MEMORANDUM

DATE: March 20, 2025 AMENDED

SUBJECT: Review of the following:

Re: Plan Commission Submittal Comments—March 25, 2025
Preliminary Plan Review Comments for Bristol Business Park—Lots 5 and 6
Tax Key IDs 37-4-121-234-0105 and 37-4-121-0106
Village of Bristol, Wisconsin (Village)

Figure 3: Proposed Sidewalks (Source: Applicant; Markup: GRAEF)

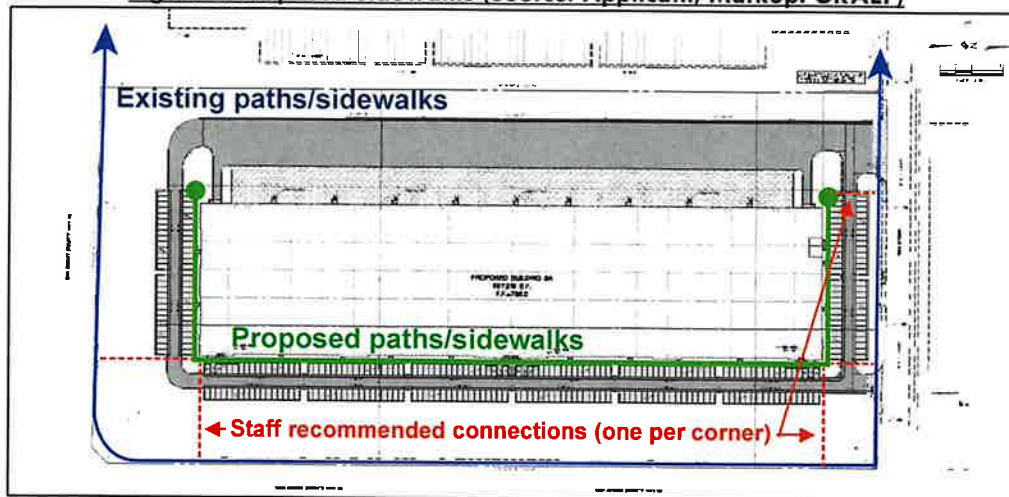
- a. Sidewalks and Paths: The proposed Site Plan shows sidewalks around the building foundation along all public facing facades. Sidewalks are not shown entering the site. There are sidewalks on the abutting 101st Street and a bike path along CTH Q and CTH U. Given the high visibility and prominence of this building in the Bristol Business Park, it is the opinion of Staff that sidewalks should be included to connect to this existing sidewalk in the right of way in a similar fashion to how they connect to the property directly to the north. Sidewalk or pathway connections should be made on each of the 3 corners indicated in the figure below (one connection per corner is sufficient).

- i. Applicant shall include additional required pathway connections to main entrances from the public way.

Figure 7: Proposed CSM (Source: Applicant)

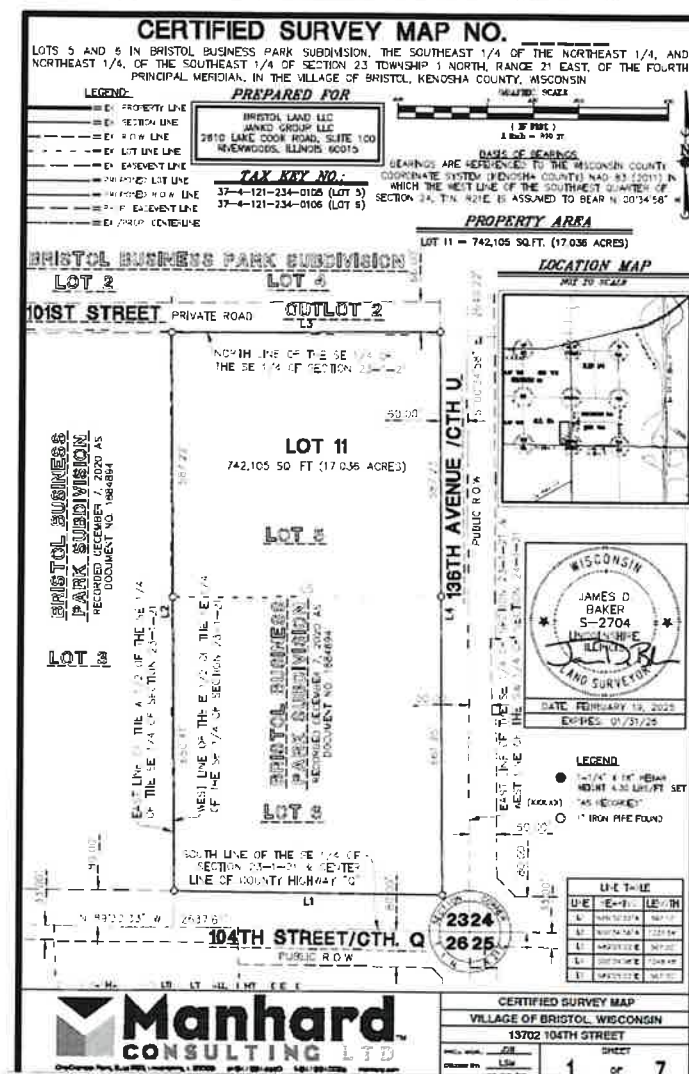
A. The original submittal for Bristol Business Park included __ lots. The Applicant has proposed combining Lot 5 with Lot 6. See Figure 6 below. Lot 5 includes frontage on CTH U and 101st St. Lot 6 includes frontage on CTH U and CTH Q. The newly created Lot 11 will include frontage on all 3 streets. ***This lot combination qualifies for a minor lot line adjustment without Plan Commission review, but has been included as a decision item at the Applicant's request.***

- B. The proposed CSM **conforms** to the dimensional requirements of the BP District and PUD Overlay.
- C. §14-1-35 and §14-1-43 specifies requirements of CSM drawings. The Village Board shall also review the technical review by the Village Engineer in the Strand memo dated March 18, 2025.
